Arlington Zoning Board of Appeals

Date: Tuesday, August 3, 2021
Time: 7:30 PM
Location: Conducted by remote participation
Additional Details:

- 3. Thorndike Place**
- 4. Thorndike Place - New Photos**

THORNDIKE PLACE

© 2020 BSC Group, Inc.
SCALE: 1" = 30'
0 15 30 60 FEET
FILE: \Civil_Drawings\2340700-GR
DWG.:
JOB. NO: 23407.00 SHEET C-105

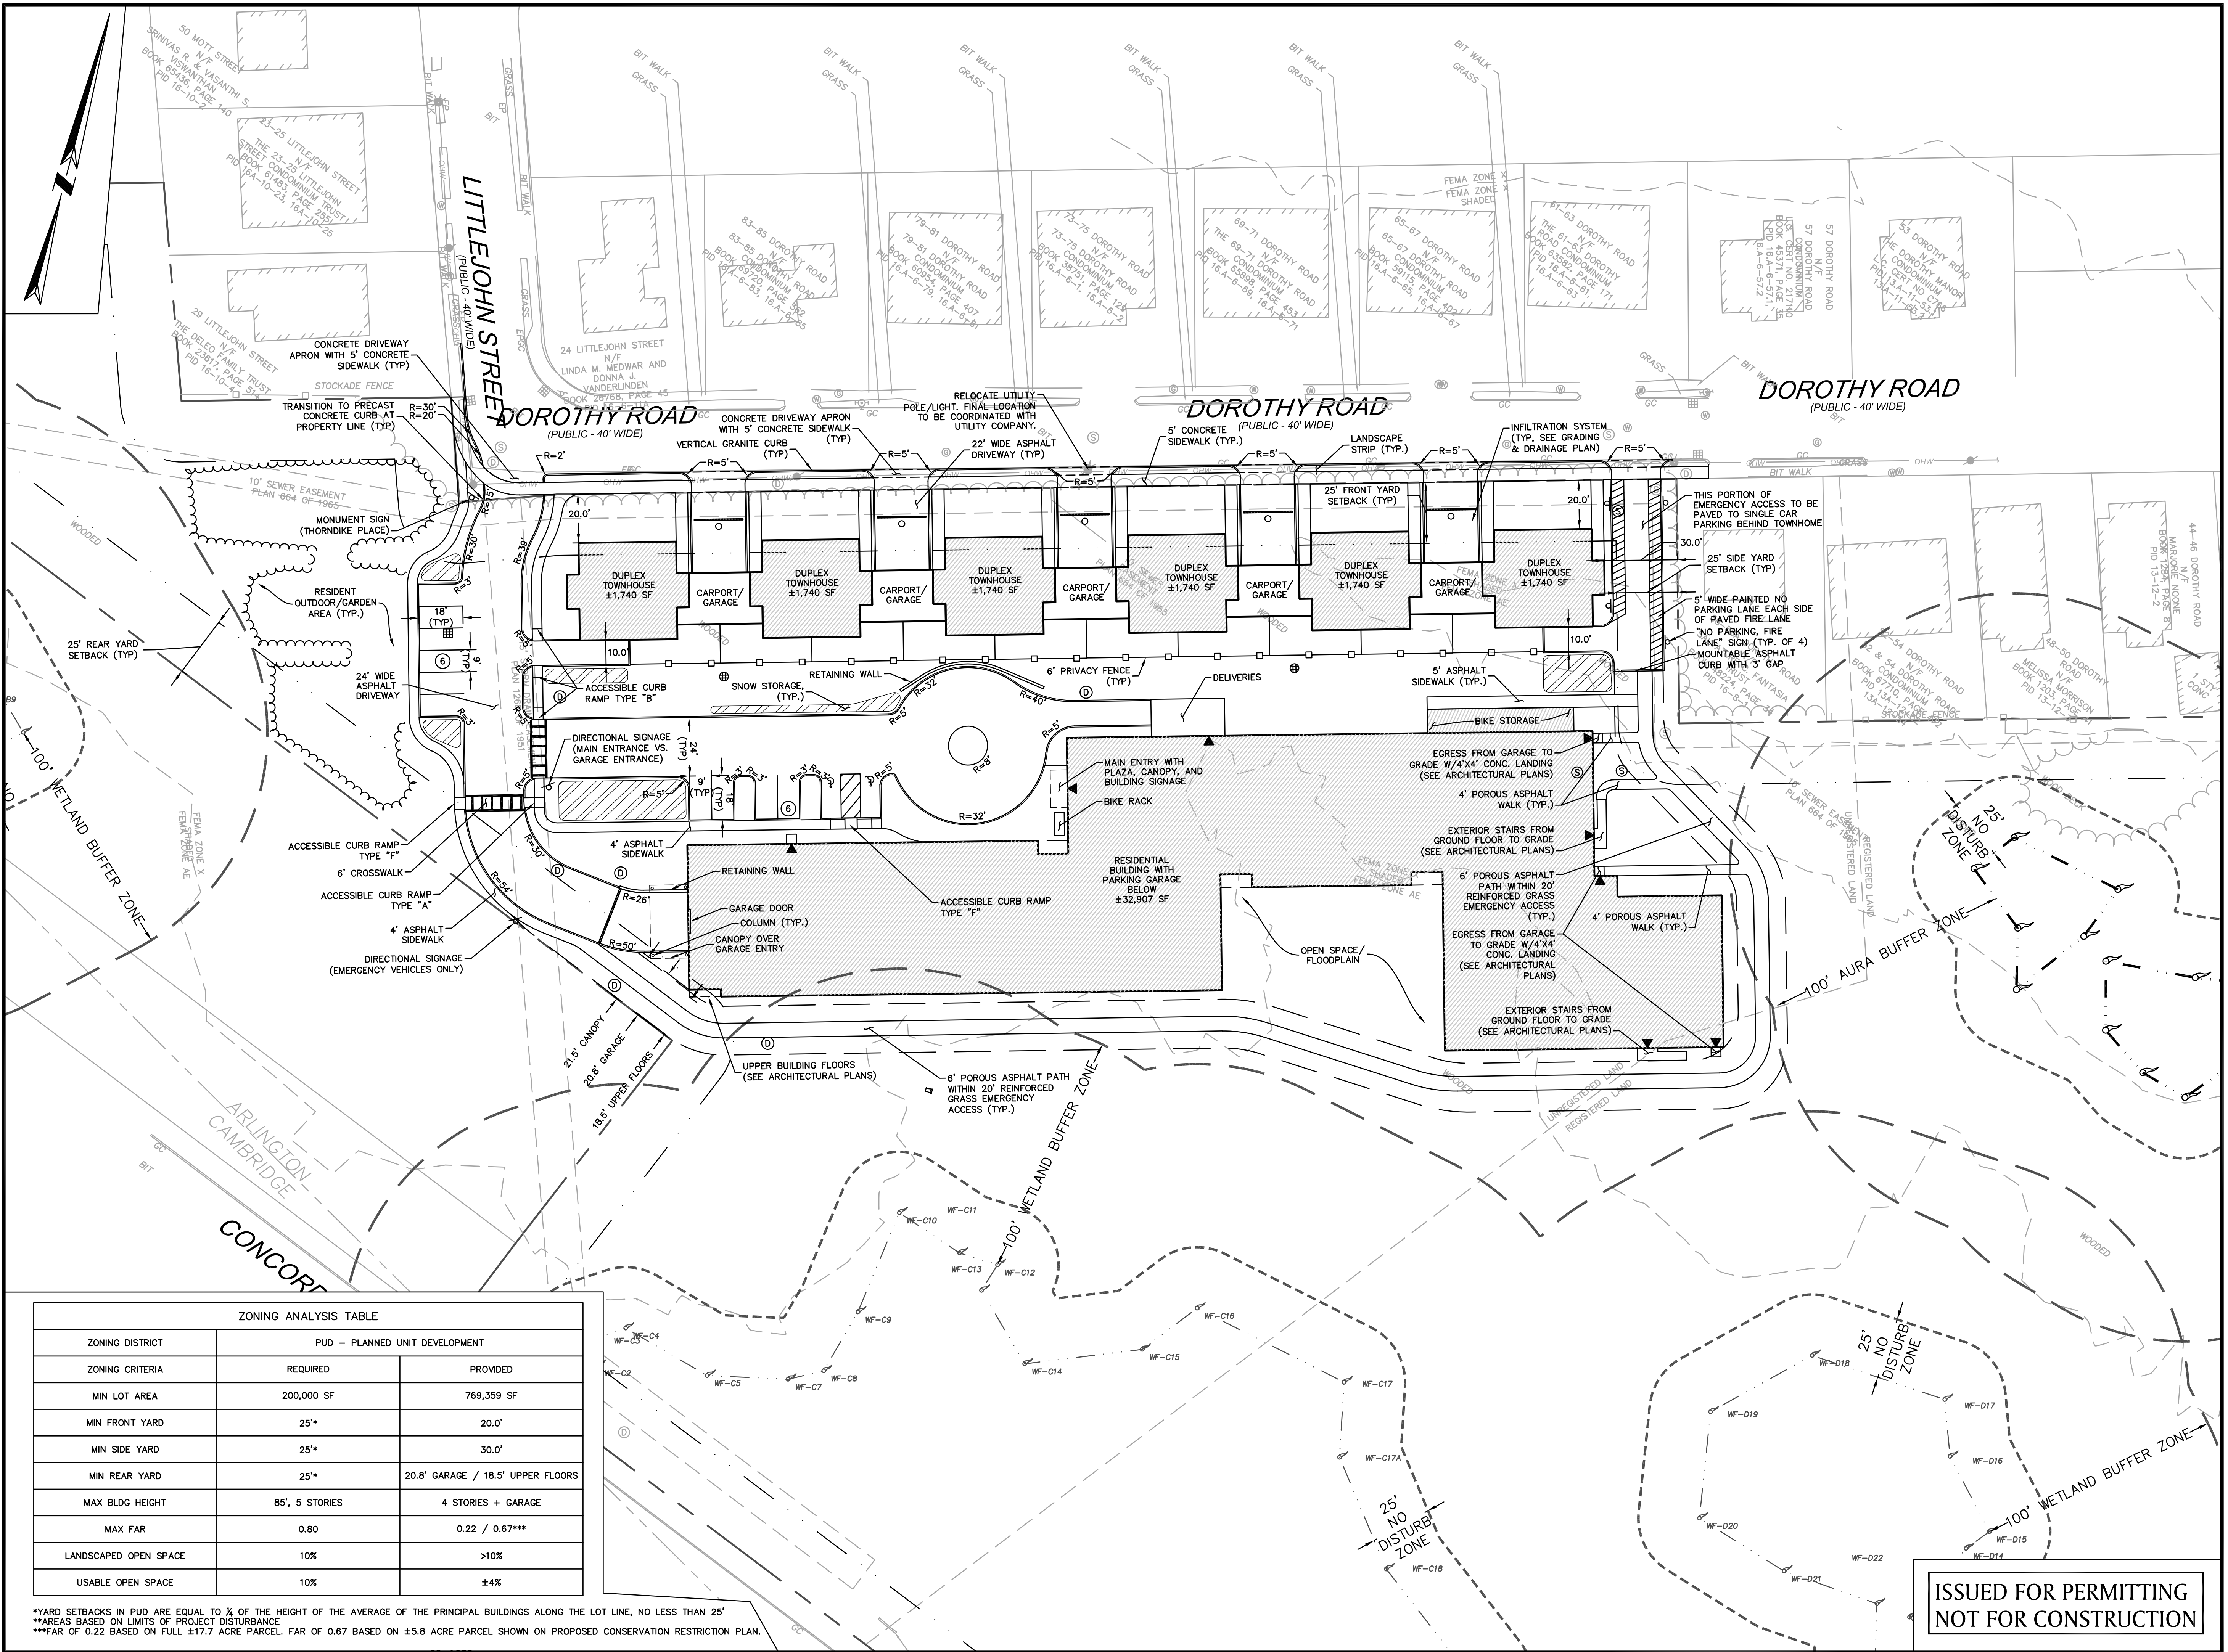
Susan Chapnick: Ms. Chapnick says that she was looking at Sheet C105 01/21/2021 and that did not correctly depict where that limit of work was in relation to the AURA? She states that was the plan that the conservation

Marta Nover: Ms. Nover, from BETA, says that she was able to pull up the plan that Ms. Chapnick referred to and states it definitely does not – it shows the footprint of the building outside of the AURA. It is really not clear that the parking was underneath it. Ms. Nover says, they will take a look at the next set of plans.

John Hession: Mr. Hession explains that some of the confusion may have been from the number of drawings. In the C105 drawing, which is the grading and drainage plan they had adjusted grading where they had pointed out that they had a couple of minor issues, and they adjusted some of the drainage structures and the connections to the building. Mr. Hession pointed out on that drawing there's a dashed line that is outside of the footprint of the residential portion of the building. It extends outside of the residential footprint to the north towards Dorothy and then in the rear, the courtyard area, where they were discussing the work in the AURA on the southwest side of the building. Mr. Hession states that the footprint of the building and the garage had not changed at all since that November 3rd full submission of both the full site plans, and that's where he believes that got confused.
